Clarification Questions

Figure 1 Indicative locations of monads where UXO engineer's support is likely to be required. Note that not all monads will be surveyed and therefore not all monads will require the UXO engineer's services.

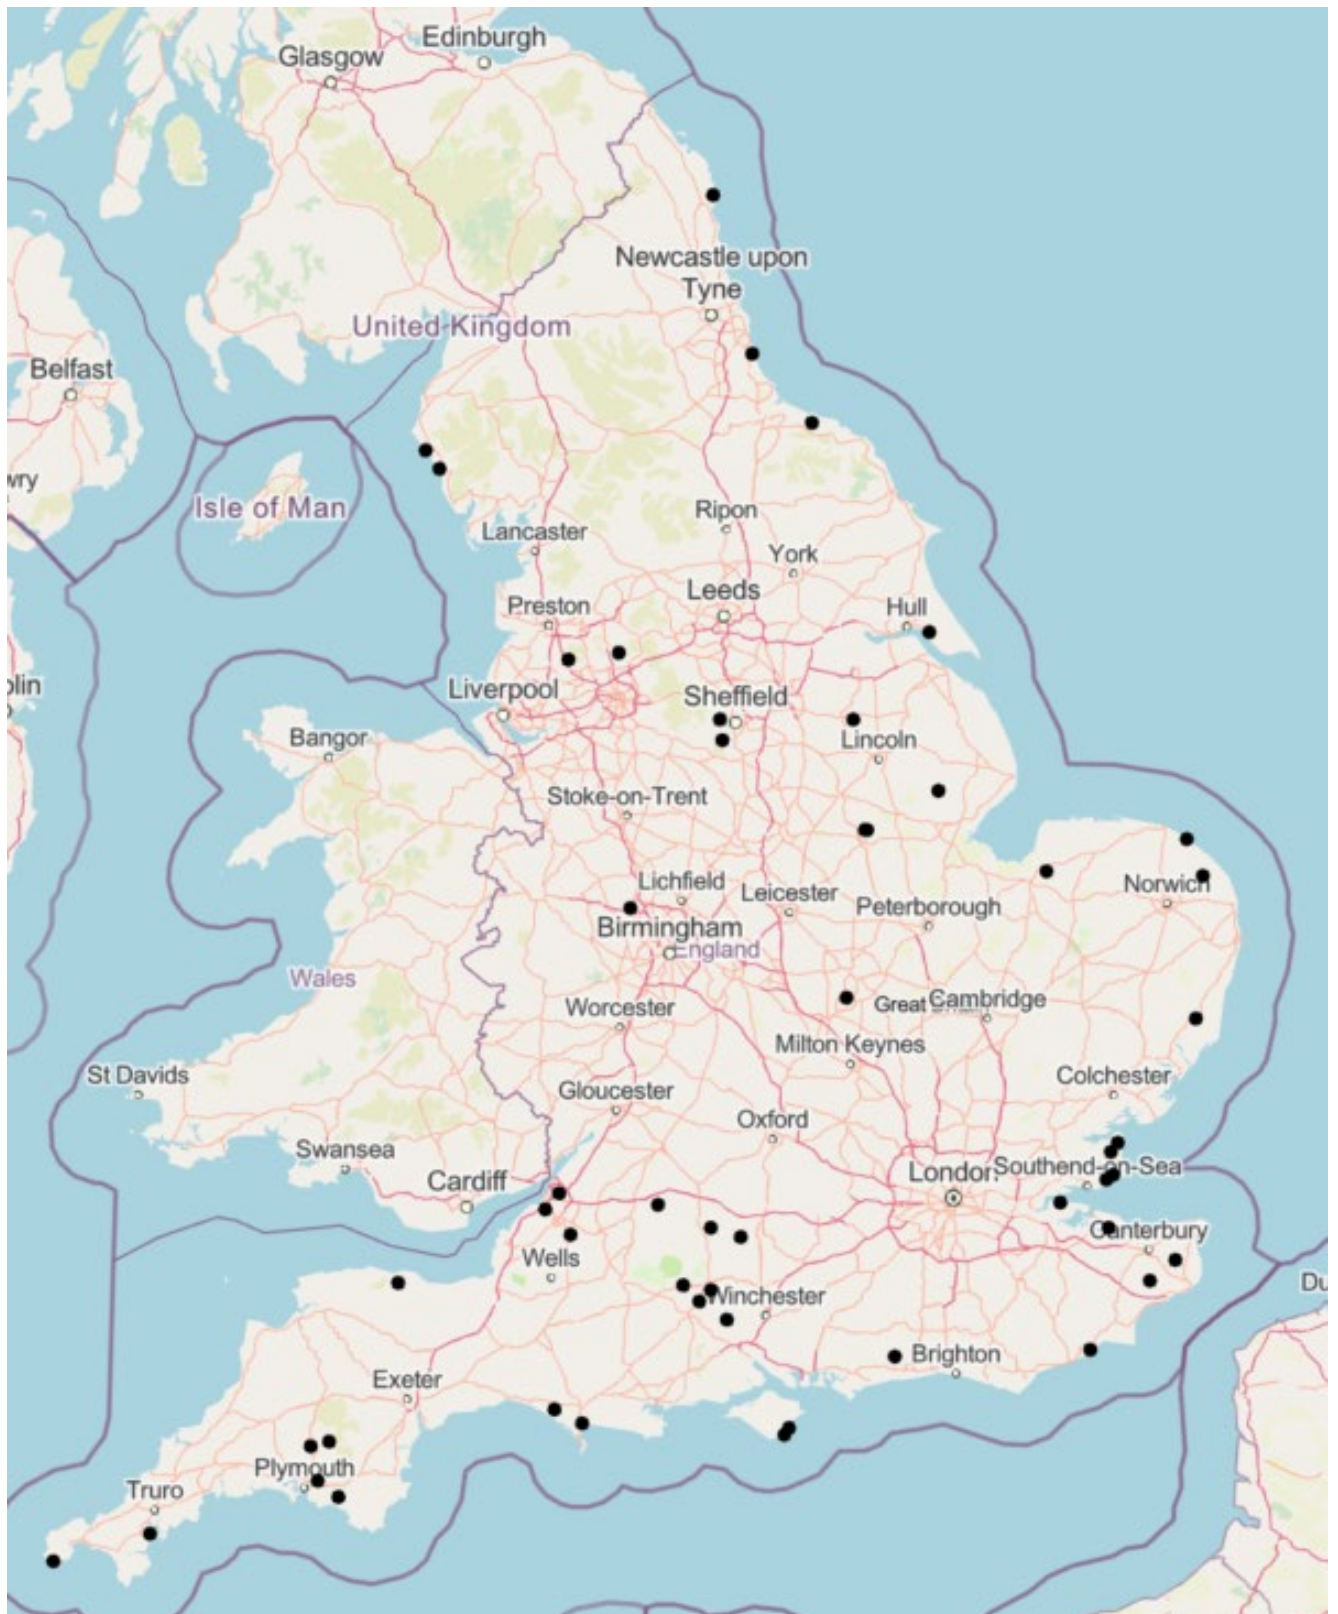
2. Breakdown of locations and project plan. In order to optimise travel and for UXO personnel planning, are the project plan and locations available yet?

Answer: Figure 1 (located on page three of this document) shows indicative locations of monads where we know that UXO engineer's support will be required as a part of this contract. Surveys are generally not located in built-up areas but can be located on open land nearby or larger open areas surrounded by buildings. Most of the work will take place before end of March 2025.
